SUBJECT: PLANS AND PROPOSAL ADDENDUMS

PROJECT: BR 2022(646)

CONTROL: 2121-05-046

**IH 10 UNDERPASS  
AT FM 3380**

**PLAN & PROFILE**

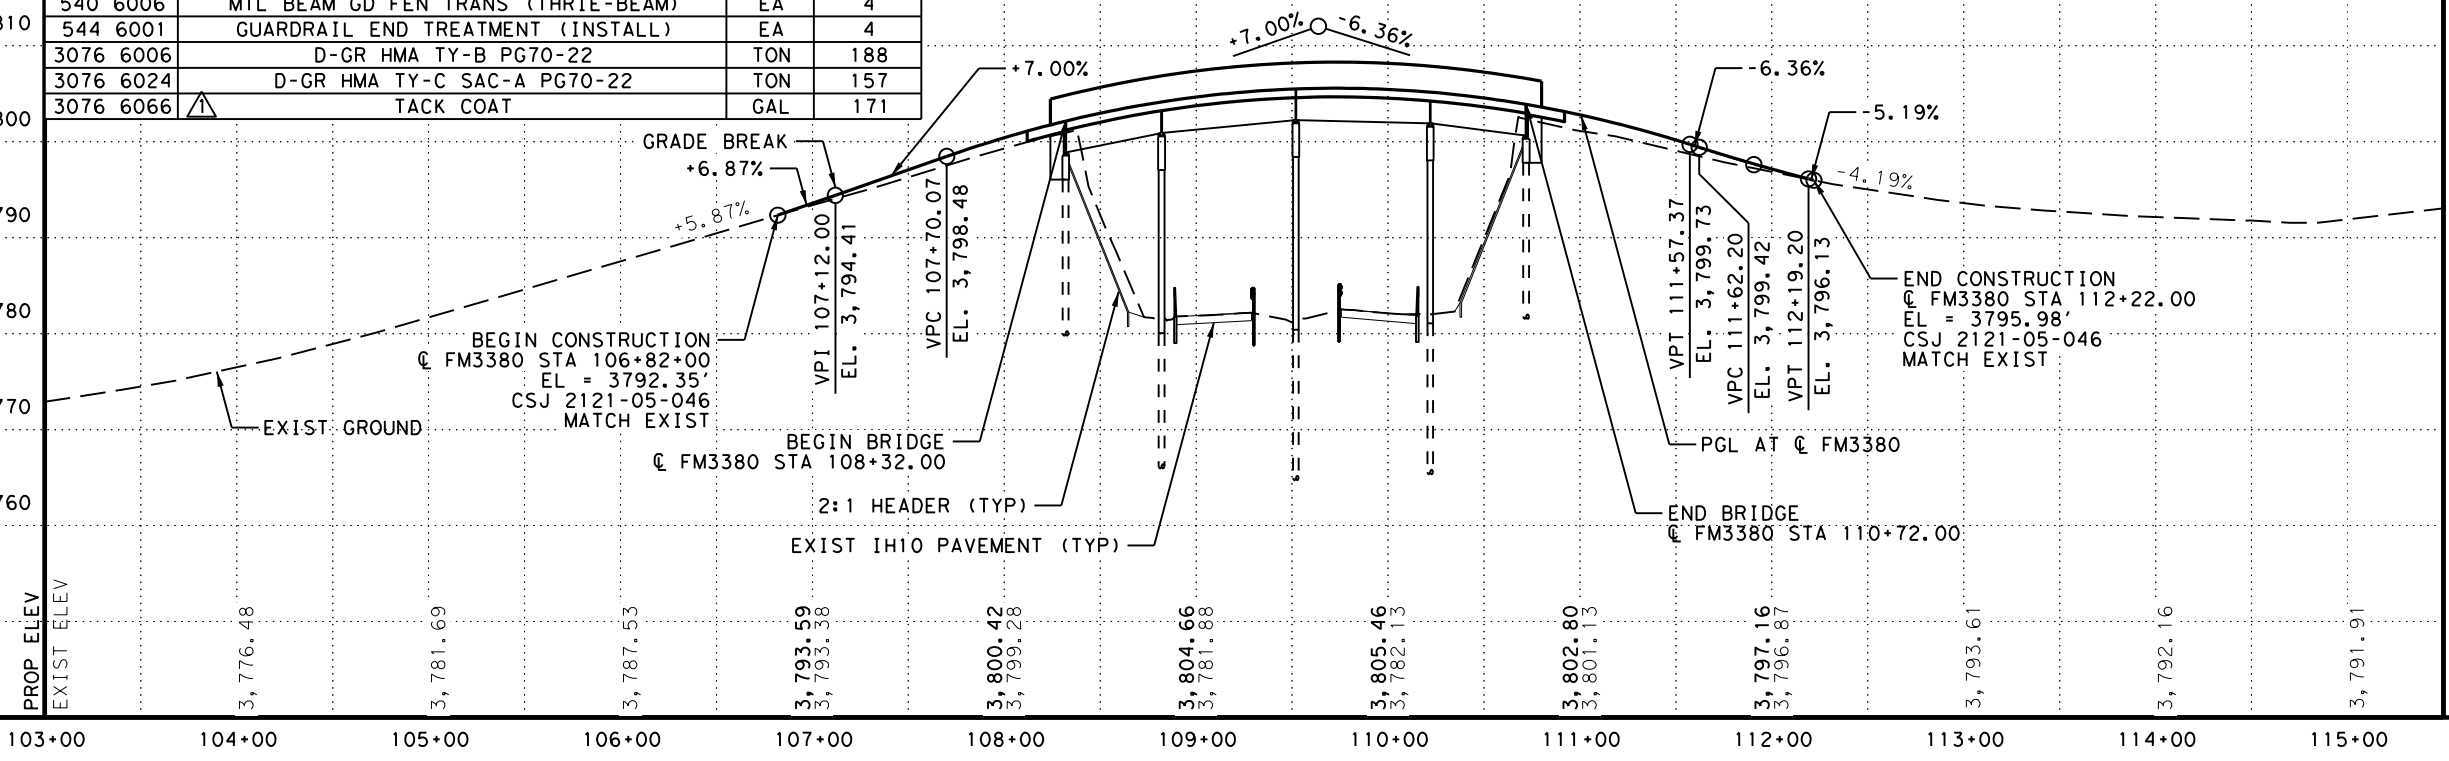
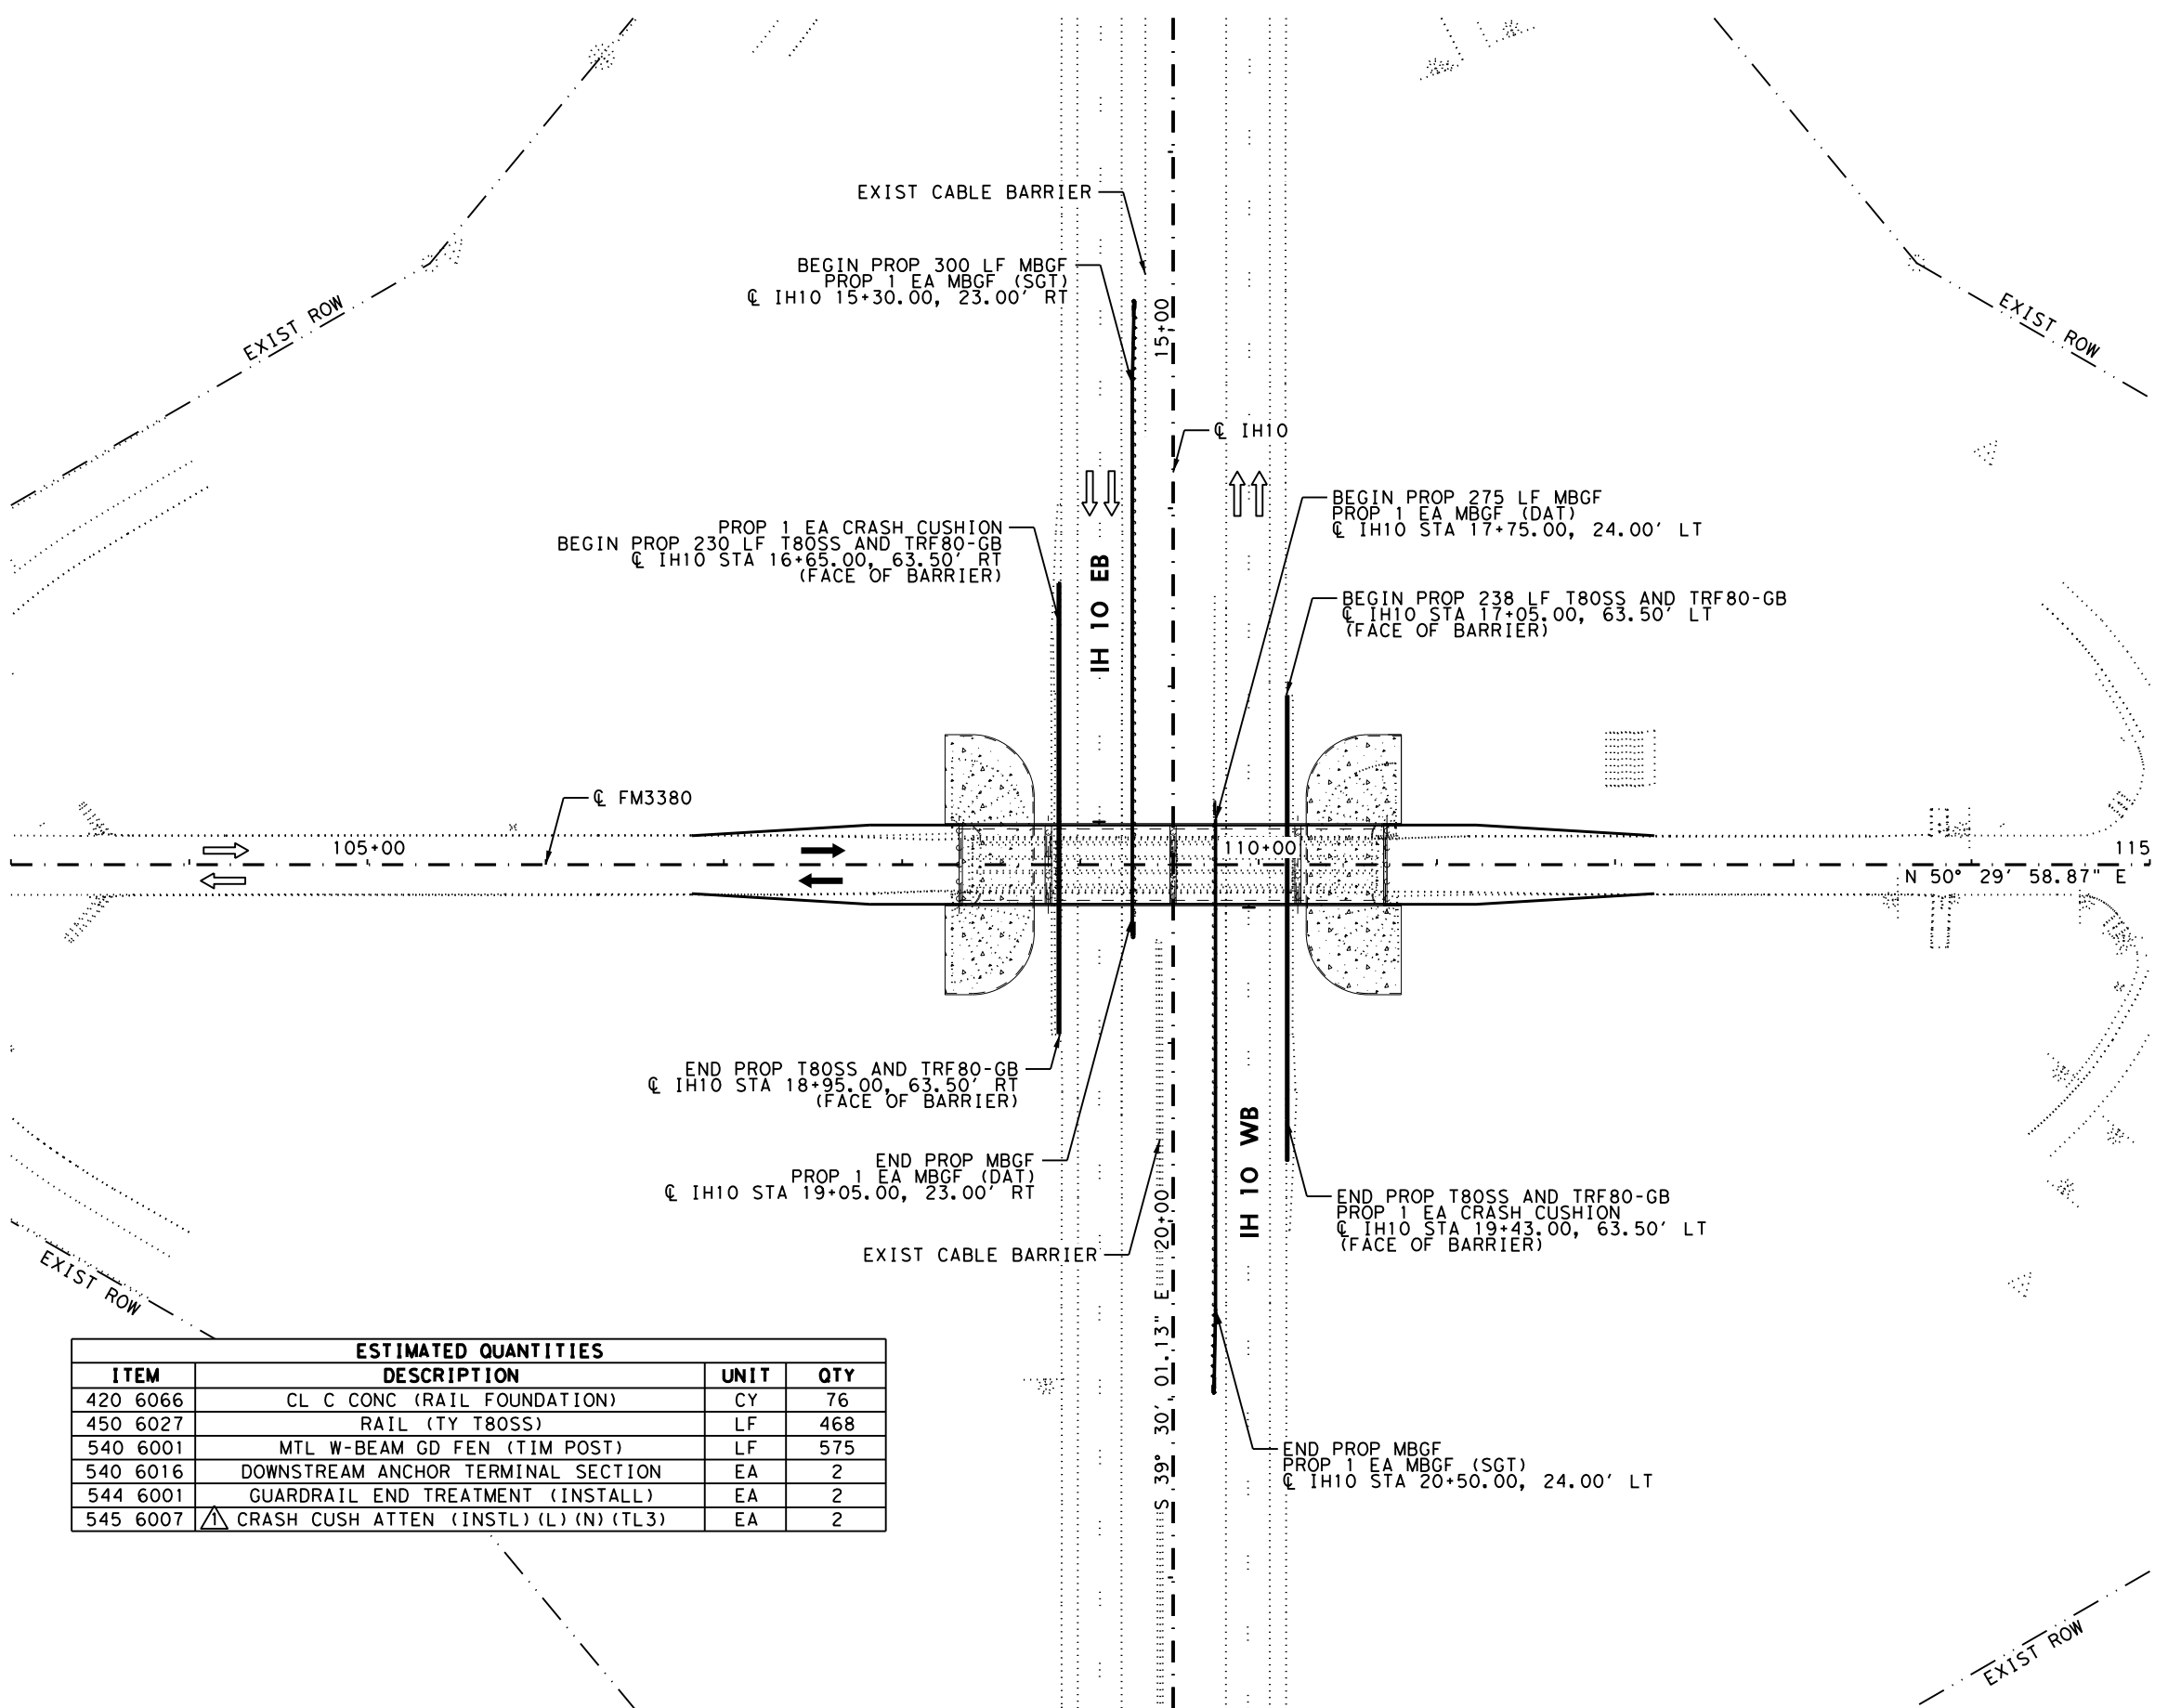
SHEET 040 (PLAN AND PROFILE): DELETE ITEM 314-6005. ADD ITEMS 310-6005, AND 3076-6066.

**BARRIER DETAILS**

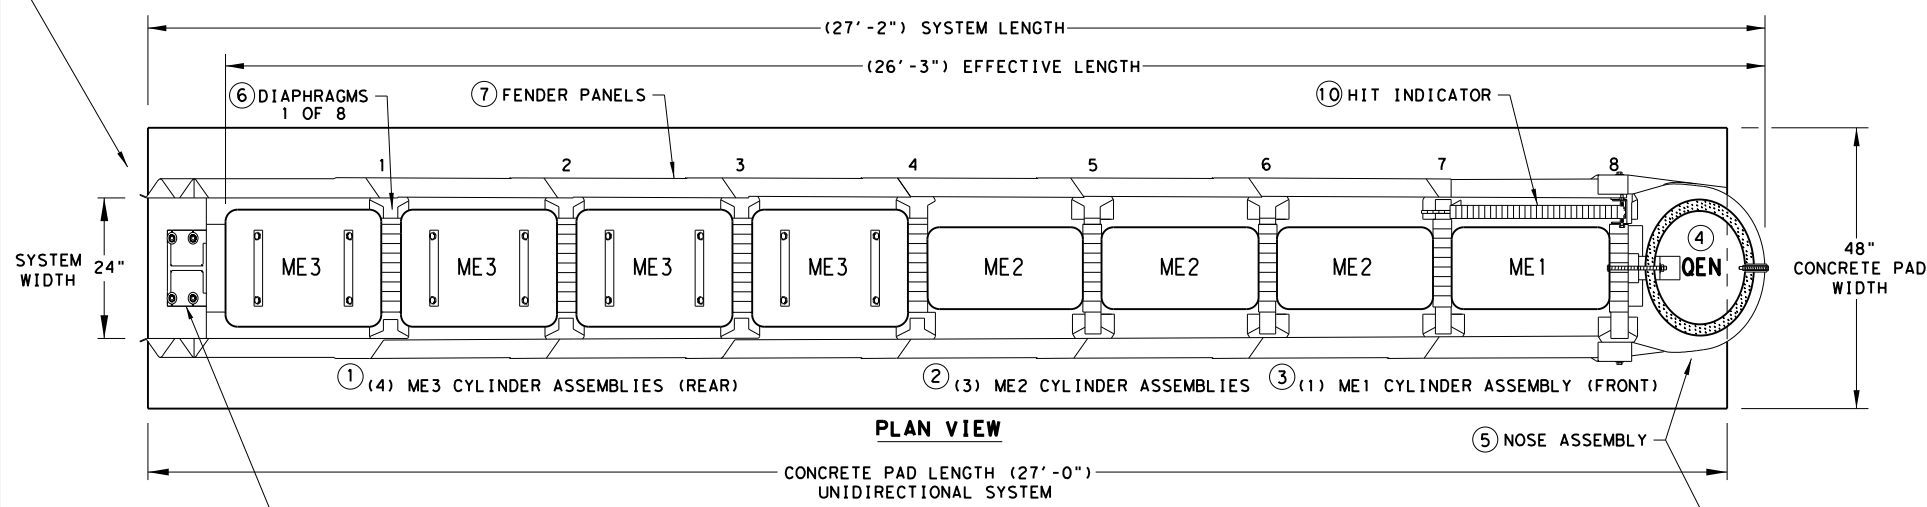
SHEET 041 (BARRIER DETAILS): REPLACED ITEM 545-6008 WITH ITEM 545-6007.

**TRINITY HIGHWAY  
ENERGY ABSORPTION  
QUADGUARD ELITE M10  
(MASH TL-3)  
QGE LITE (M10) (N) -20**

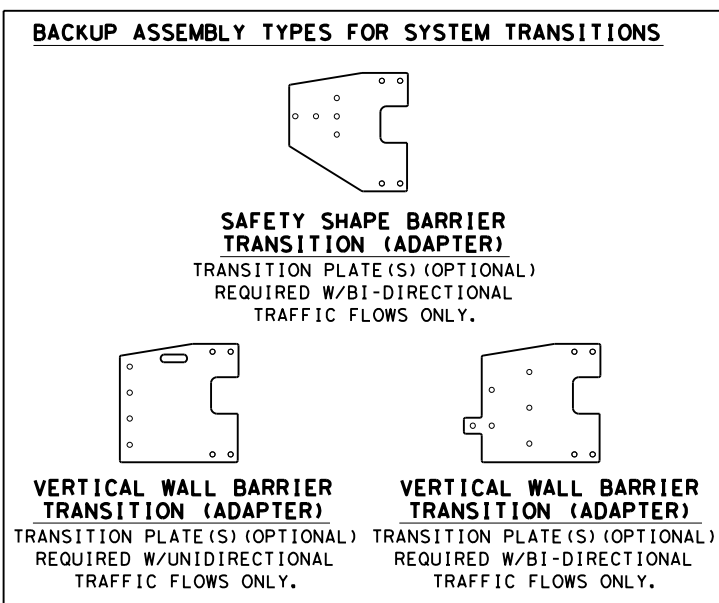
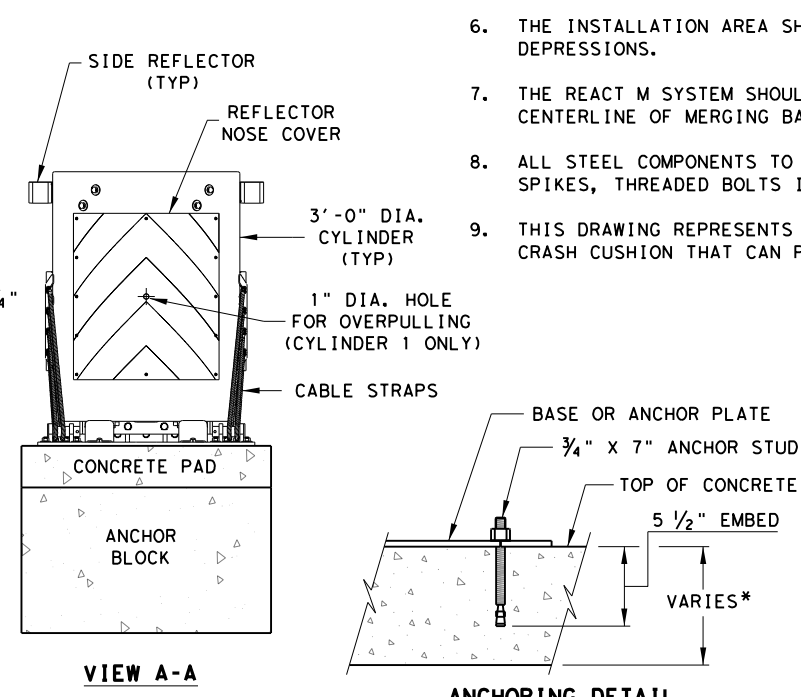
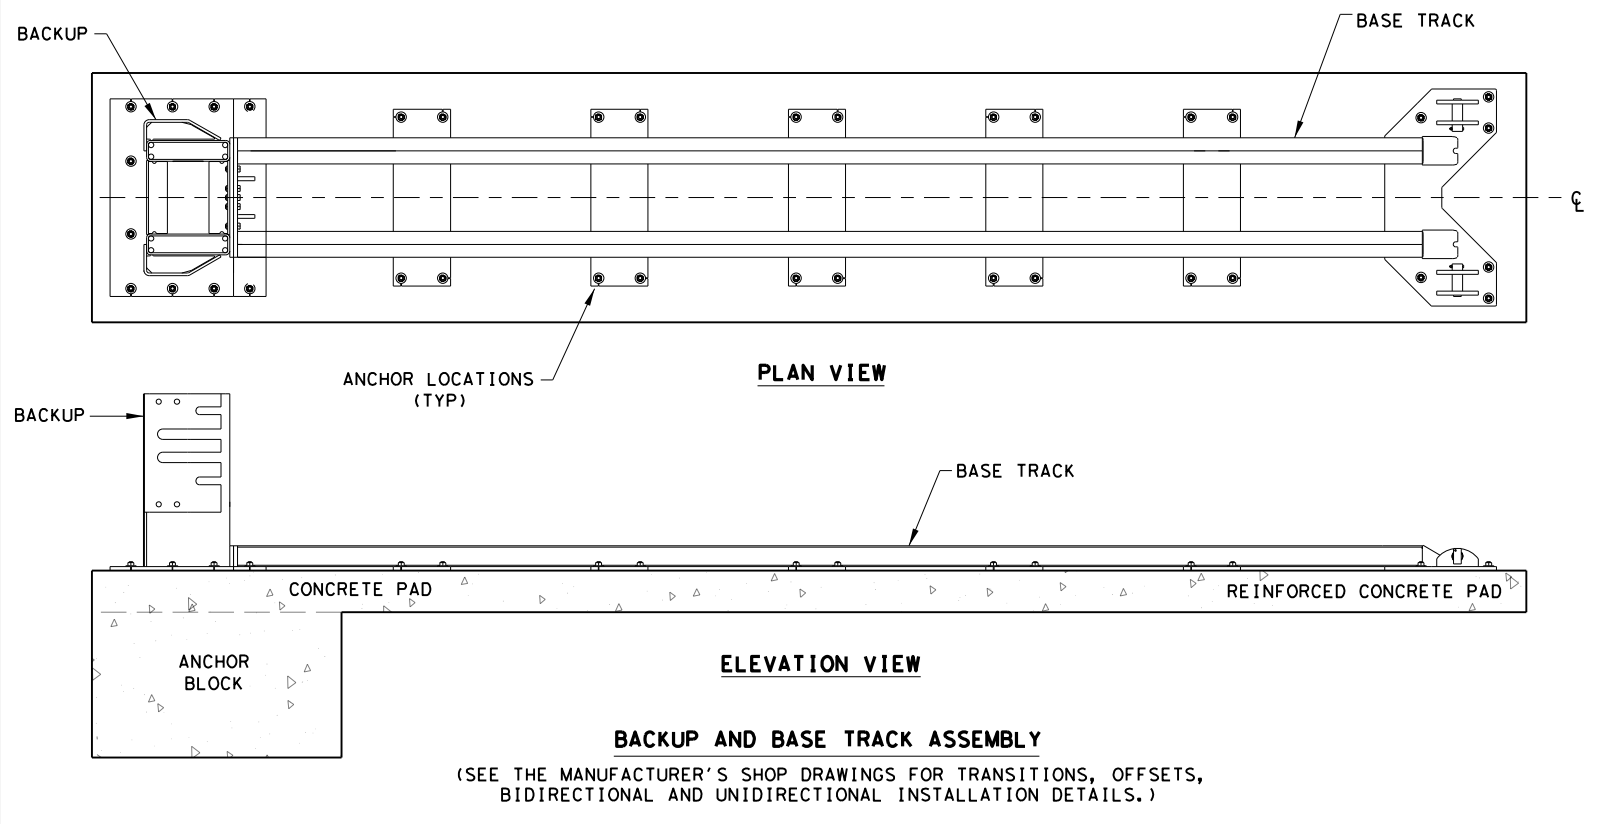
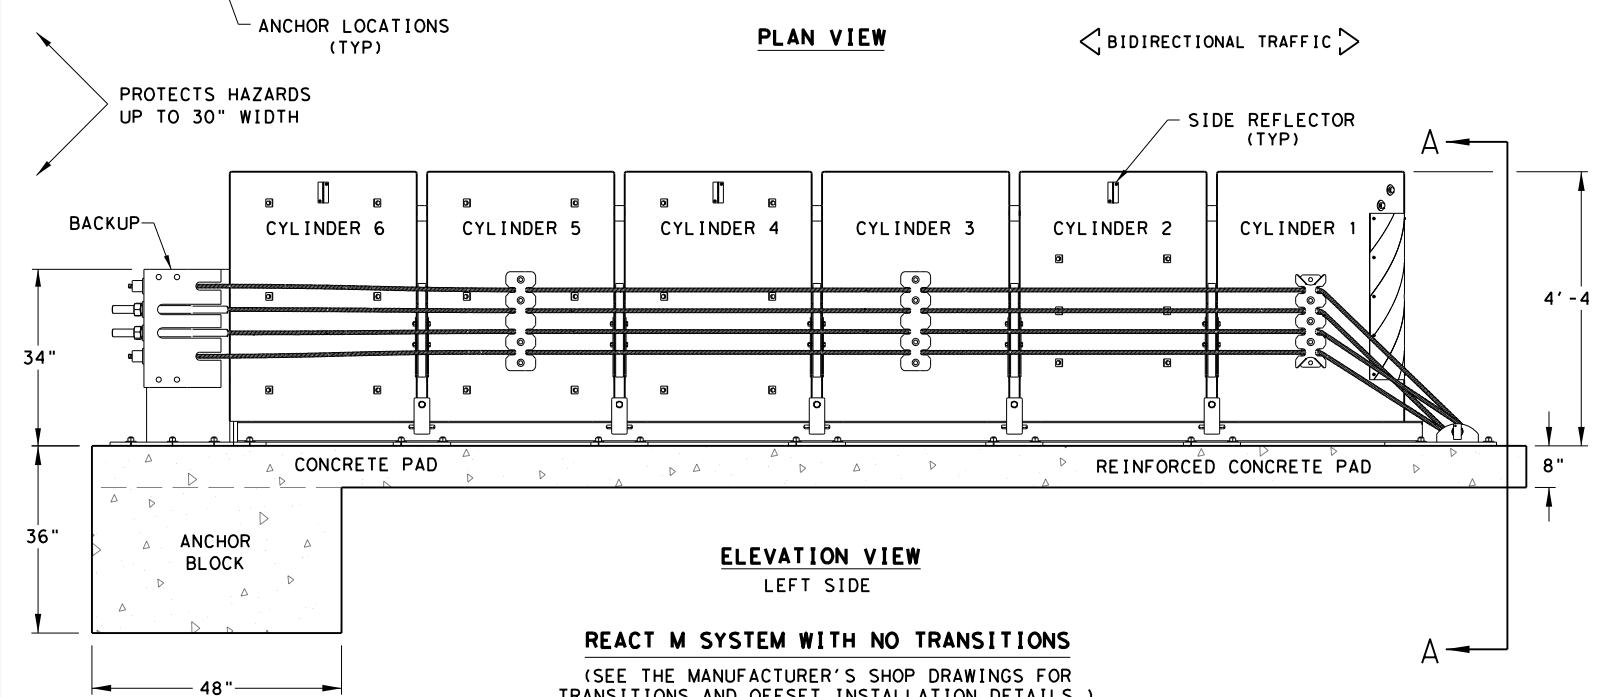
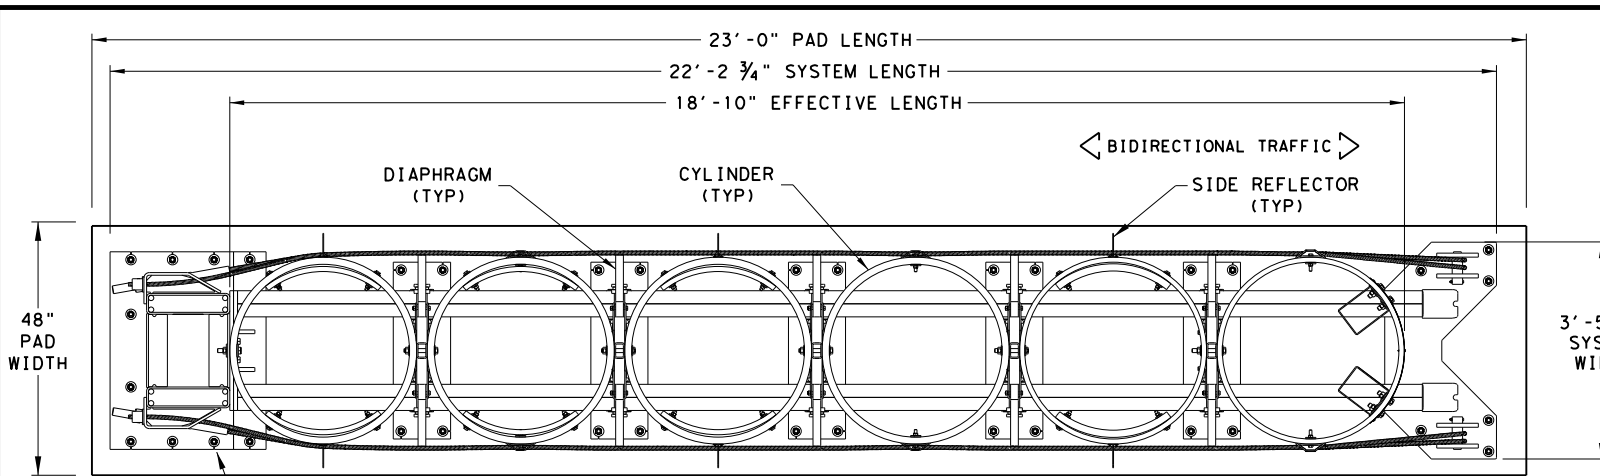
SHEET 055: REPLACED STANDARD TAU-II-R(N)-16 WITH STANDARD SHEET QGELITE(M10)(N)-20.
